CHESTER GATE GARDEN - TRANSPORT RESPONSE

1. This transport response has been prepared following comments made on the planning application for Chester Gate Garden (planning ref: 2016/1479/P).
2. This response should be read in conjunction with the Transport Statement prepared by Caneparo Associates and submitted as part of the planning application.
3. The comments made on the planning application can be categorised under the following topics, each of which is addressed in turn.
 - I. Traffic Impact;
 - II. Parking;
 - III. Access;
 - IV. Highway Safety; and
 - V. Cumulative Impact (Cycle Superhighway & HS2).

Swept Path Analysis Using a 9m Refuse Vehicle - Proposed

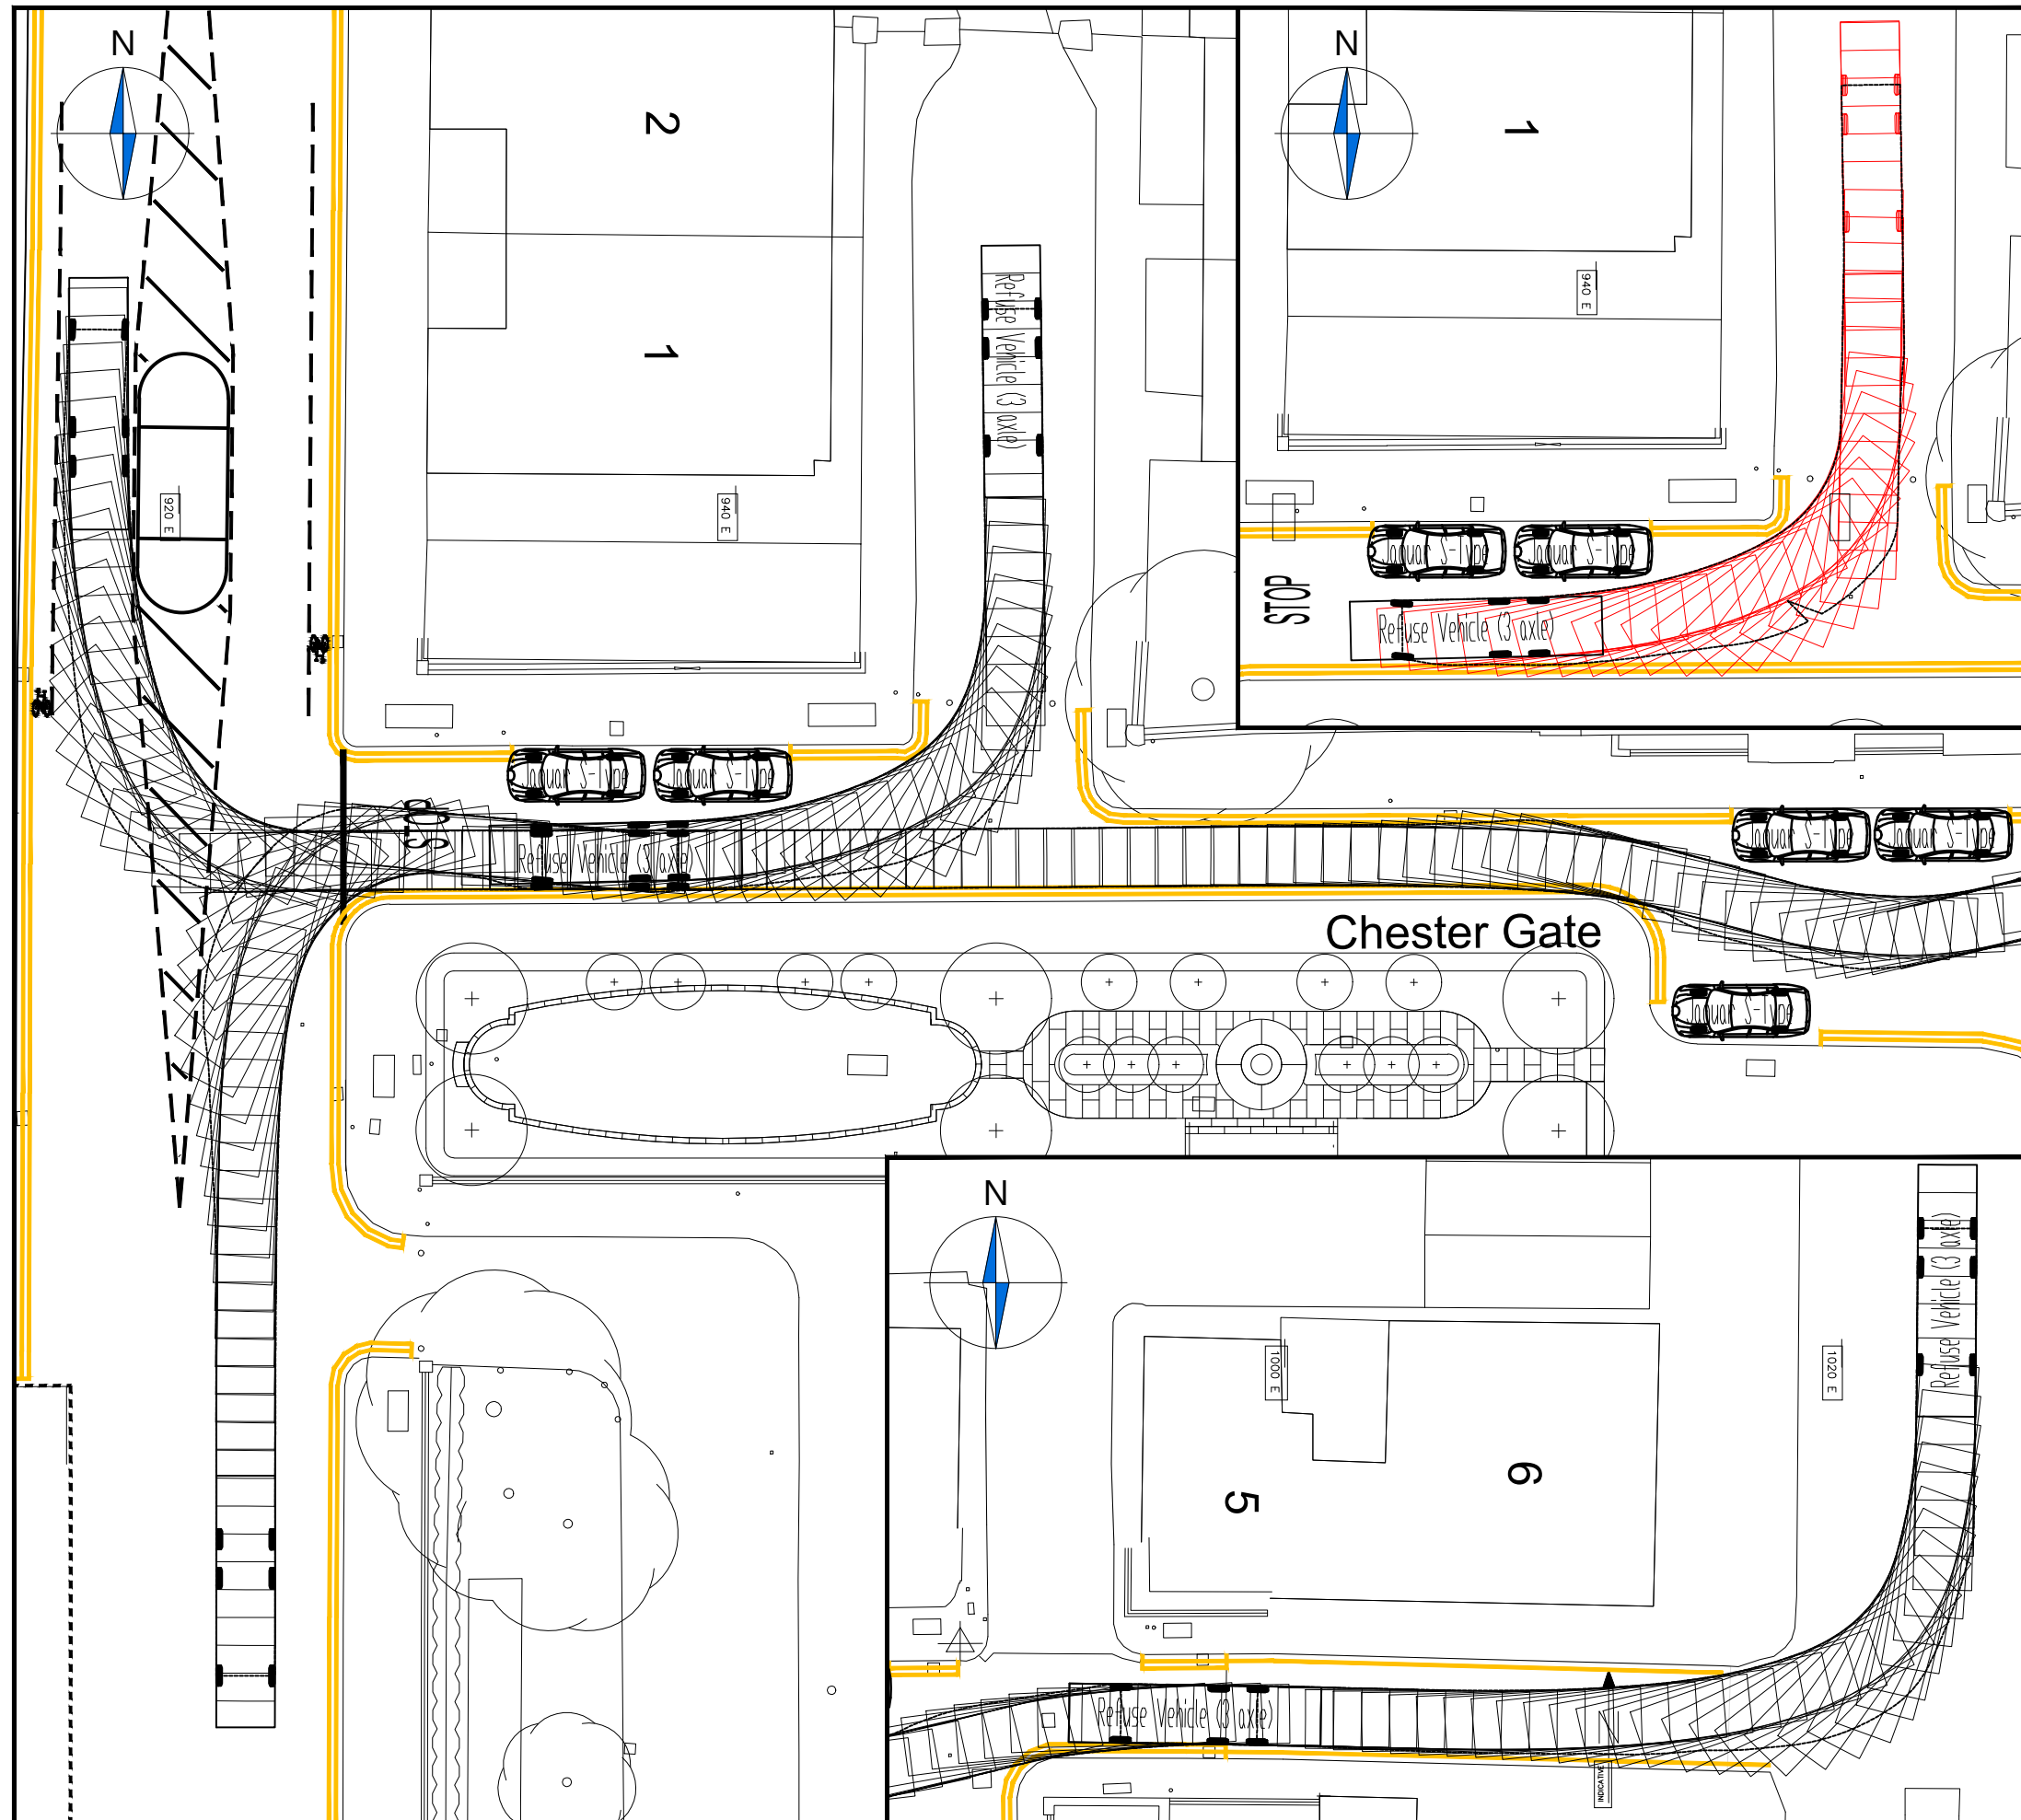
15. The swept path analysis also addresses one of the recommendations made in the Road Safety Audit, which queried whether a large vehicle could pass parked cars on the north side of Chester Gate.
16. The proposed width of Chester Gate between the junction with Chester Terrace and Outer Circle is approximately 5.6m, which is sufficient to enable cars to park on the north side of the carriageway and allow a car to pass and exit to the left or right to Outer Circle. Whilst there is no designated cycle lane on Chester Gate, the width afforded at the junction with Outer Circle would be more than sufficient to accommodate a cyclist and a vehicle. This is evident when one considers that guidance set out by the DfT recommends a width of 3.8m for a car to pass a cyclist.

14. The proposed layout of Chester Gate shows 4-5 remaining parking spaces. As demonstrated by the swept path analysis at **Appendix A**, a large refuse vehicle would still be able to negotiate Chester Gate when the parking spaces are occupied. The swept path analysis takes account of vehicle overhang and shows the wheel tracks for the vehicle and also, the outline of the body of the vehicle. As can be seen, the body of the vehicle does not overhang the kerb.
